Serial No.: 10/695,018

Atty Docket No.: JCLA11476-R2

AMENDMENT

Discussion of Drawings Objection

FIG. 2B

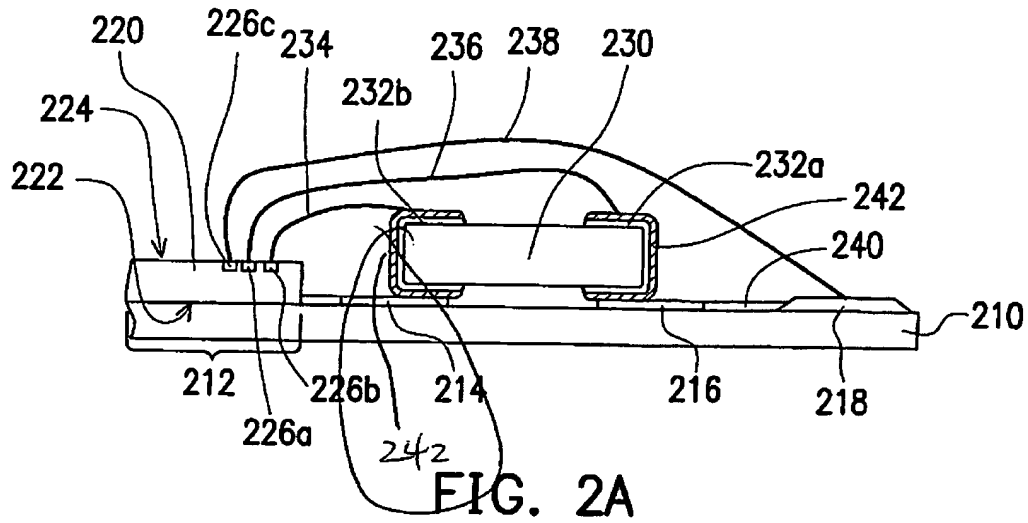
Figures 1B and 2B are objected to as failing to comply with 37 CFR 1.83(a) because they show inconsistent dispositional relationships between the passive component and the electrodes 132b and 232b and it is not clear whether the electrodes are at the top end of the passive element or at the sides thereof.

In response thereto, Applicants have amended Figures 1A, 1B, 2A, and 2B to clarify the dispositional relationships between the passive component and the electrodes 132b and 232b and to clarify that the electrodes are at the top end and bottom end of the passive element. Withdrawal of the objection is respectfully requested.
